**Subject:** TIME-SENSITIVE: Concerns & Questions re Handling of 136 Brentwood Ave (Res 4), in City Staff Report #DSD-2024-061: Proposed Jackson/Brentwood Development

**RE: City Staff Report #DSD-2024-061**

**(Pertaining to Amendment Applications OPA24/002/J/BB and ZBA24/002/J/BB: Proposed Jackson/Brentwood Development)**

**Figure 6 – Proposed Servicing through 136 Brentwood Avenue**

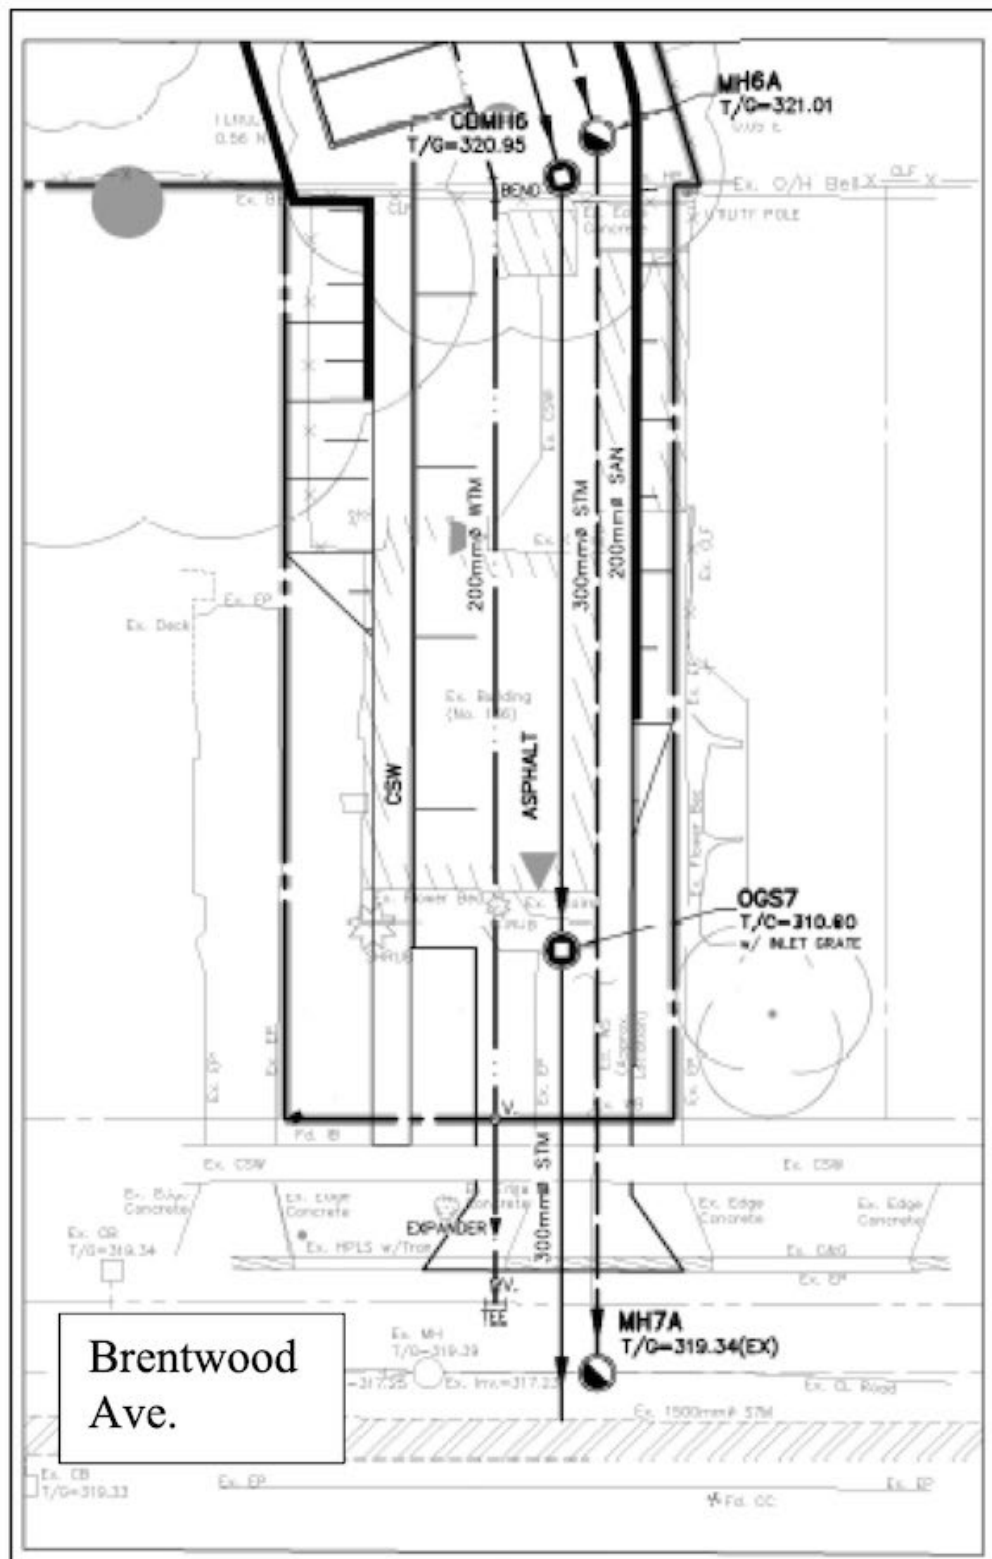
- i/ There does not appear to be any parking proposed on the 136 Brentwood property, at the Initial Conceptual phase. This is the 136 Brentwood Site Plan rendering that was shared and discussed at the Feb. 21 Public Meeting.
- ii/ However, when you look at Figure 3, and particularly at the enlarged Figure 6, while the labels are illegible, you will note the Revised rendering proposes, along the left- and right-side lot-lines, 5 full-sized vehicle parking spots, as well as what appear to be parking locations for smaller motorized vehicles (e.g. motorcycles) and/or Class A Bicycle parking/lockers and/or perhaps garbage and recycling bins.

**A/** Why does the Report (consistent with the Feb. 21 Public Meeting) refer to the proposed use of the 136 Brentwood property, CONSISTENTLY AND ONLY as an “access laneway,” when it is apparent, in these Revised Site Plans Figures, that parking (and perhaps garbage/recycling collection) is a proposed use for a portion of this property?

**B/** What, indeed, are each and all of the site features rendered in Figure 6, and illegibly labelled in versions shared to the public?

However, a careful tally of the parking spots rendered on the Res 5 portion (i.e. “situated internal to the site”) of the Revised Conceptual Plan, PLUS the 5 parking spots rendered on the 136 Brentwood property, equal the total number of spots the Report indicates will exist, given the cited 1.02 ratio. Why was the location of the totality of surface parking misrepresented / not disclosed, in the City Staff’s written Report?

**Figure 3 – Revised Conceptual Site Plan, March 2024**

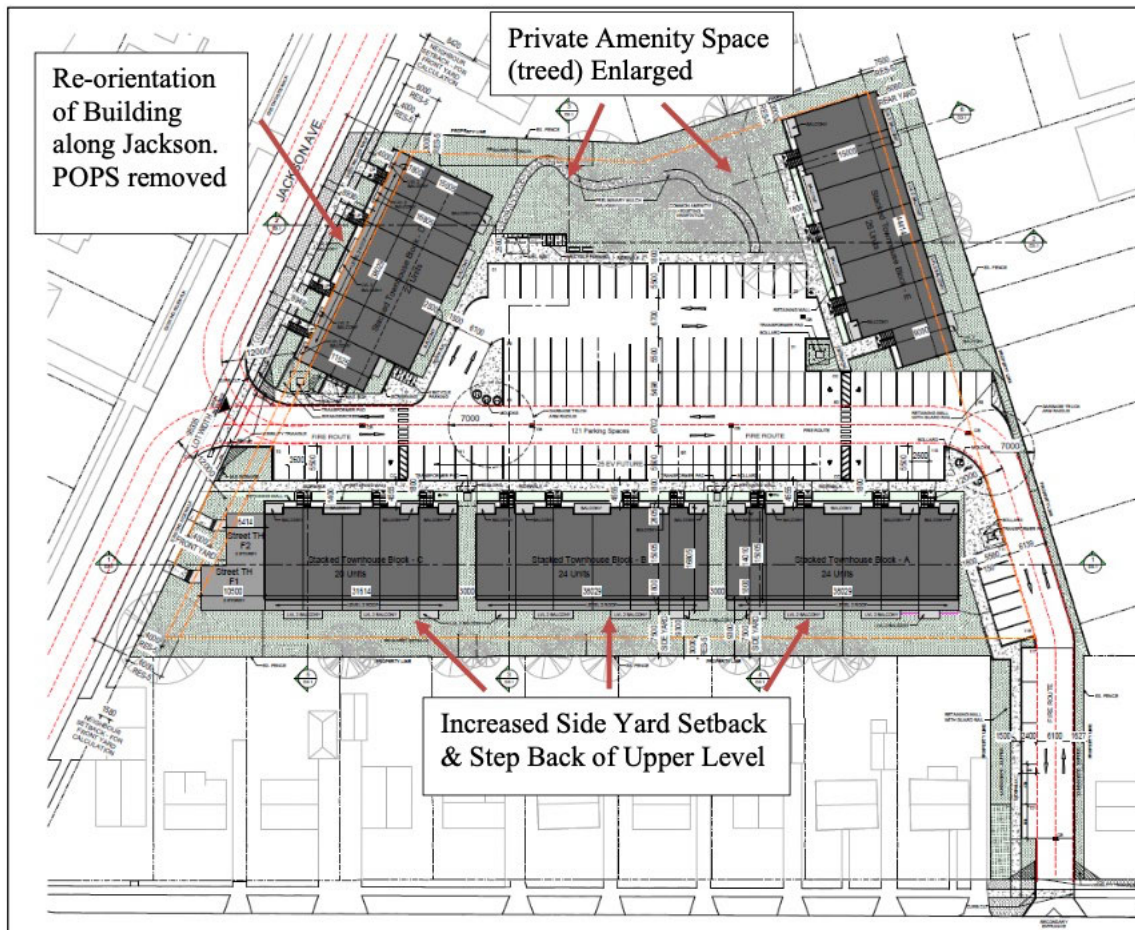
- A/** In combination with my preceding points (particularly my observation regarding parking spot tallies in my section “**3C,**” above), and in reviewing the proposed parking spot layout and traffic flow of the “internally situated” parking plan rendering in Figure 3, might it be most logical to assume that the developer “requires” 136 Brentwood Ave as a laneway and parking area, primarily in order to meet parking requirements?
- B/** If the developer genuinely believes that a secondary lane is required, in case of emergency, does he not have the option to again readjust building orientations, in order to achieve this goal, which is not actually required by Bylaw nor any other governing Policy?
